DEVELOPMENT REVIEW BOARD
Code Enforcement Comments

(AKA: PR-2021-006287)
PR-2021-006297
SD-2022-00039 – PRELIMINARY/FINAL PLAT

REQUEST: SUBDIVIDE ONE LOT INTO FOUR LOTS

Screen shot excerpt of 3/9/22 submittal showing allowed "Net Lot Sizes" for Area of Consistency:

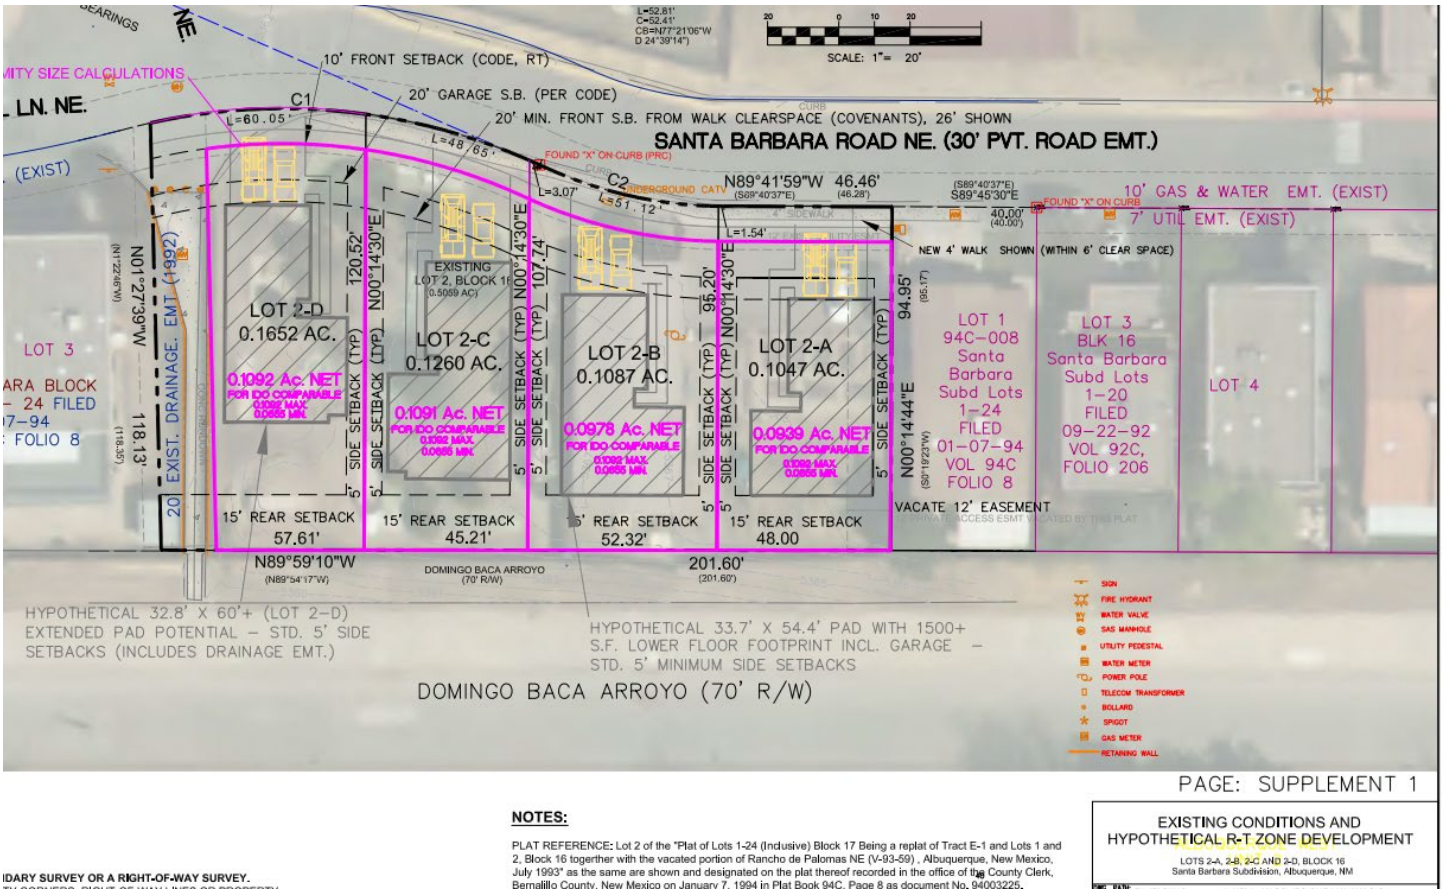
1. Property is zoned R-T and is located in an Area of Consistency. All standards and requirements of the IDO, DPM, and other relevant City regulations must be met.
2. As per prior communications with Planning Staff and calculations of Area of Consistency, these lot sizes must fall within .0655 acre minimum (75%) and .1092 acre maximum (125%) for consistency. The modified net size of proposed lots falls within what is allowed by the Area of Consistency calculations.
3. No additional comments or objections.
